# City of Warrenton

## STAFF REPORT

TO: The Warrenton Development Review Committee  
FROM: Jay Blake, Planning Director   
DATE: May 17, 2023  
SUBJ: Review of Site Design for Nygaard Land, LLC on a portion of Parcel #810340002301. Address unassigned, but approximate address is 1XXX SE Warrior Way  
APP #: PRE-23-08

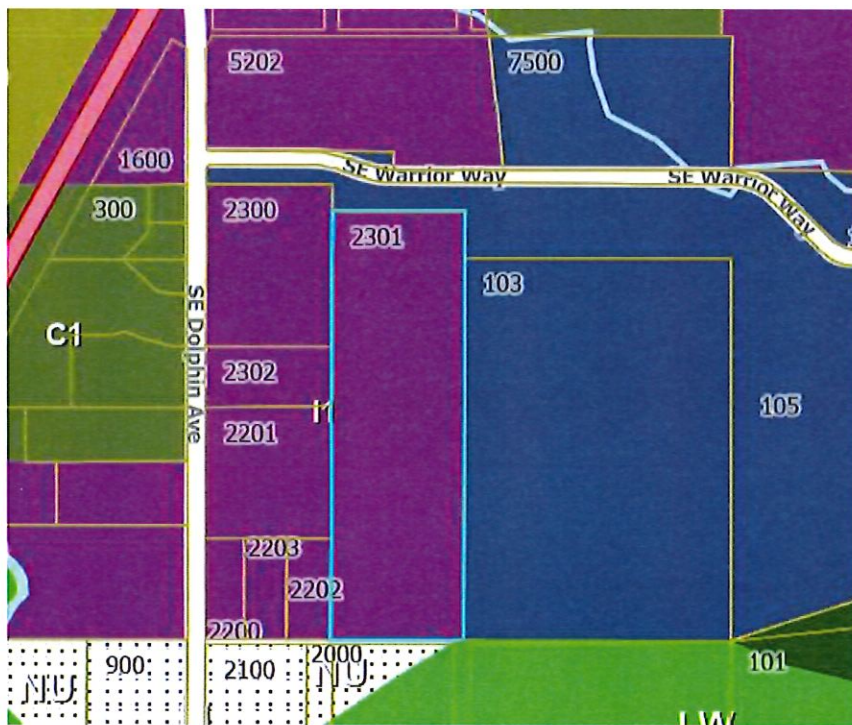
13. The Site Plan indicates the development of 489 storage units, with 252 inside ground access units, 237 exterior access units, and 21 canopy units (RV storage sites). There are no density number standards in the Municipal Code for this use.

14. Access will be from a newly created shared public road built on the easterly property line and in conjunction with future development plans for the school facilities. They are proposing a left turn lane from the new road to the existing Warrior Way. The applicant should coordinate construction plans for road improvements with the Warrenton School District to improve parking and future traffic flows on the newly created public street.

19. Internal traffic flow should allow for adequate fire equipment access and garbage/recycling truck access. Garbage facilities shall be screened from view from the public right-of-way. Internal parking should not restrict fire access within the project area. Internal traffic flow should be indicated on future plans.

21. Parking spaces shall be provided for 1 space per 1,000 sf of mini-warehouse/mini-storage building area or 2 spaces per employee, **WHICHEVER IS GREATER** (emphasis added). Bicycle parking shall be incorporated into final designs. Current calculations show that there is roughly 90,000 sf of warehouse

structure. This would require 90 parking stalls. This is not reasonable and the applicant should consider a variance to this requirement. If on-street parking is incorporated into the road improvement plans, the applicant can be given credit for the new parking stalls. As currently shown, there are five (5) spaces provided.
